PLANNING AND ZONING COMMISSION MEETING

Subject: Consider recommendation on request for approval of a revised Preliminary Plat for Fox Run Plat 2.

RE: PRELIMINARY PLAT –COMMENT RESPONSE LETTER
FOX RUN PLAT 2
OUTLOT Z OF FOX RUN PLAT 1
INDIANOLA, IOWA
S&A Project No: 121.0091.01

PRELIMINARY PLAT - TITLE SHEET

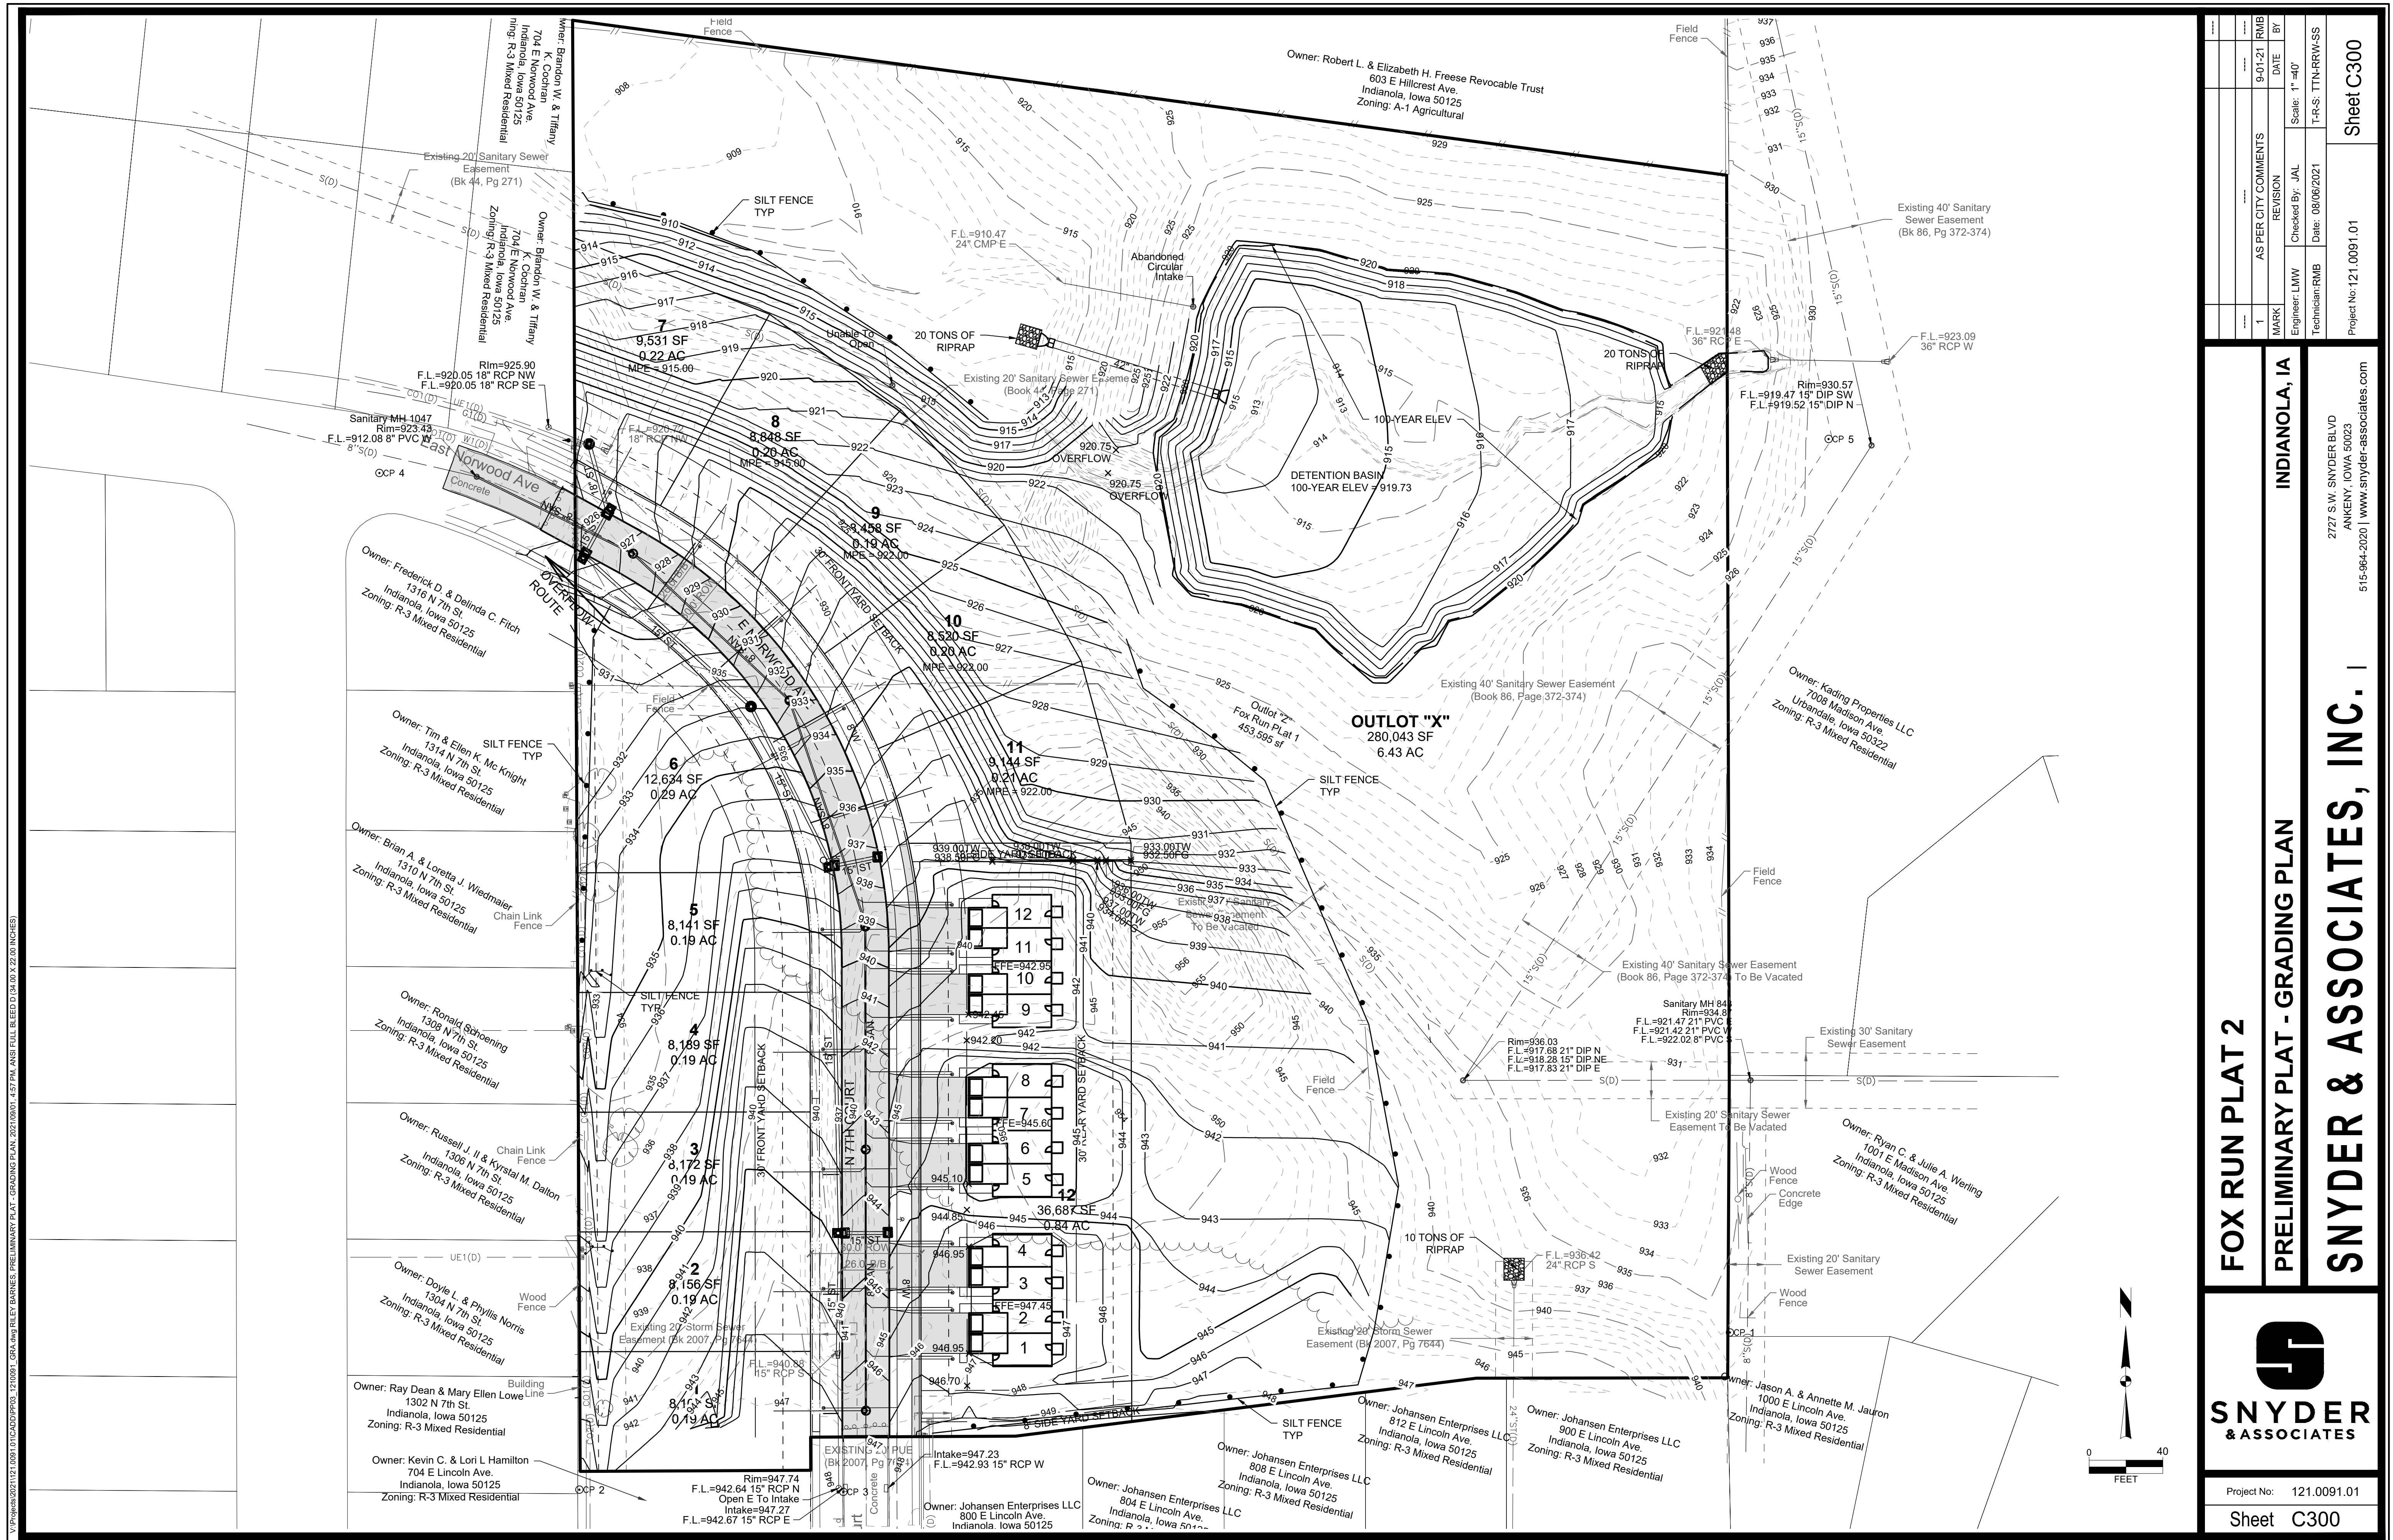
1. Please update the Zoning to show R-2, Single-Family Attached Zoning District.
The zoning on sheet C100 has been revised to show R-2, Single-Family Attached Zoning District.

2. Please update the bulk regulations to show:
 - SINGLE-FAMILY DWELLING (LOTS 1-11)
MINIMUM LOT AREA = 7,200SF
MINIMUM LOT WIDTH = 60'
FRONT YARD SETBACK = 30'
REAR YARD SETBACK = 35'
SIDE YARD SETBACK = 8'

- TOWNHOMES (UNITS 1-12)
MINIMUM LOT WIDTH = 24'
FRONT YARD SETBACK = 25'
REAR YARD SETBACK = 30'
SIDE YARD SETBACK = 8'
MIN. SEPARATION BETWEEN PRINCIPAL BUILDINGS = 16'
MIN. SETBACK FROM THE PERIMETER OF THE DEVELOPMENT = 30'**The bulk regulations have been revised on sheet C100.**

6. Please note the dedication of street lots to the City, as well as the dedication of Outlot X to the City.
Note 5 has been added to sheet C100 about dedication of the street lot and Outlot to the City.

7. Please provide a note that states utility easements shall convey to the City, its successors and assigns, the perpetual right within the areas shown on the plat and described in the easement, to construct, reconstruct, operate and maintain electric lines consisting of poles, wires, cables, conduits, fixtures, anchors and other similar equipment, including the right to trim or remove trees within such areas where necessary to secure a clearance of 4 feet from the wires or poles, together with the right to extend to any telephone, telegraph, electric or power company, the right to use separately or jointly with the City, the areas included in the easement for the purposes above enumerated.
Note 6 has been added to sheet C100 that states this information.

13. Add the following note in Sheet C100: All pavement designs shall be based upon an in-situ subgrade soils investigation hired by the City and performed by a qualified Geotechnical Engineering consulting firm and licensed professional engineer in the State of Iowa. (As a part of this design process, City will conduct a geotechnical report for the site, at the developer's expense, focusing on where the public infrastructure will be installed.)

14. Add the following note in Sheet C100: No paving activities, including placement of curb and gutter, will be allowed until soil reports have been submitted, approved and/or corrective action taken on deficient test results.

Note 8 has been added to sheet C100 that states this information.

Note 9 has been added to sheet C100 that states this information.
